**REQUEST FOR ADDITIONAL INFORMATION
INSERVICE INSPECTION PROGRAM
RELIEF REQUEST HC-RR-B12
HOPE CREEK GENERATING STATION
FACILITY OPERATING LICENSE DPF-57
DOCKET NOS. 50-354**

**SUBJECT: REQUEST FOR ADDITIONAL INFORMATION RESPONSE - HOPE CREEK
GENERATING STATION RELIEF REQUEST HC-RR-B12 (TAC NO. MB8407)**

REQUEST FOR ADDITIONAL INFORMATION
HOPE CREEK GENERATING STATION RELIEF REQUEST HC-RR-B12

Figure 1

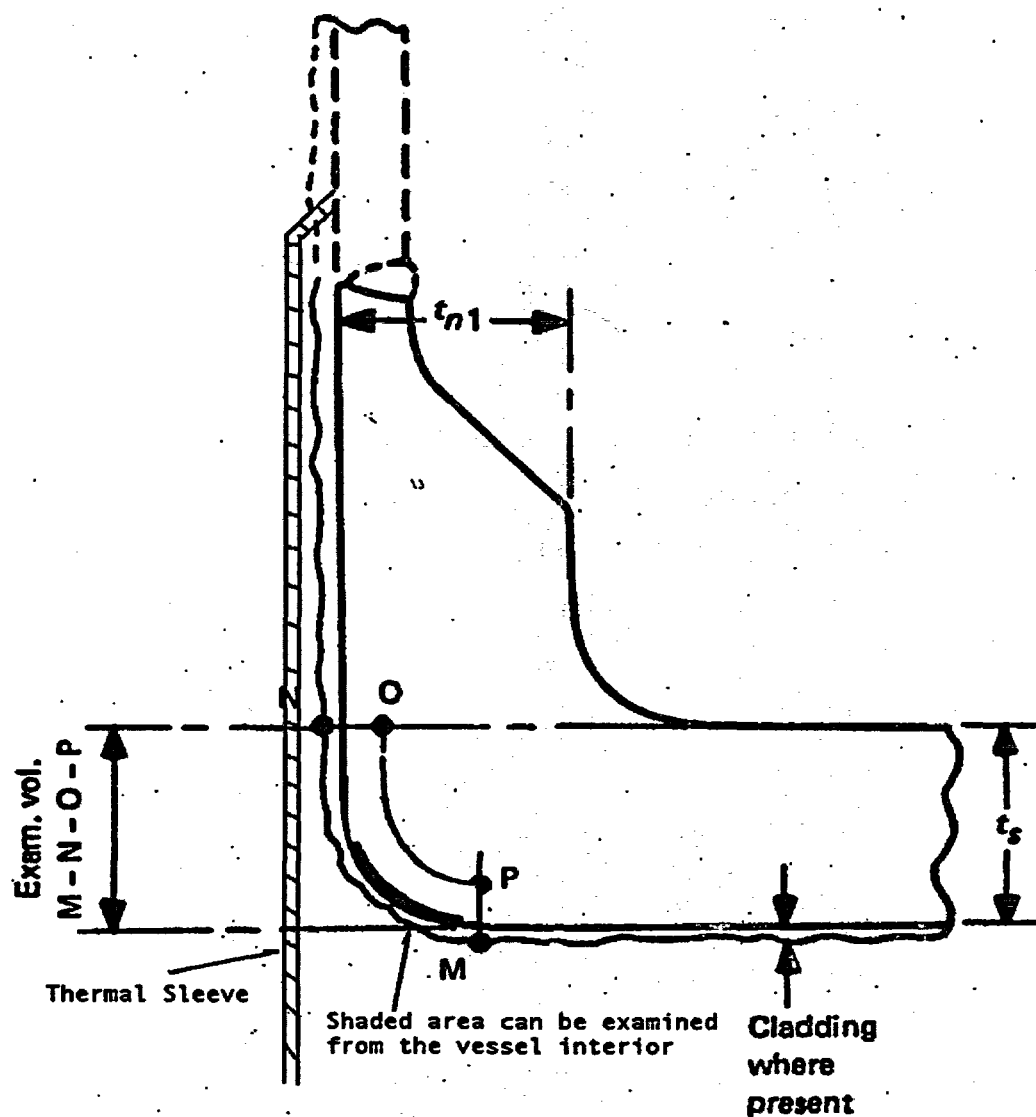
The licensee states the estimated coverage of each nozzle in Table 1 of its submittal. The list fails to state specific information about which area of the nozzle will be inaccessible to examination (e.g. top, side, bottom). The severity of thermal fatigue is dependent upon the circumferential location, thermal gradient and thermal sleeve leakage. Describe the portion of each nozzle that will be inaccessible to examination, providing a sketch if possible.

The area of the nozzle that is inaccessible is portrayed in Figure 1 below and should be considered to be 360° around the circumference of the nozzle inner radii area and limited to the approximate surface area shown within between M-N.
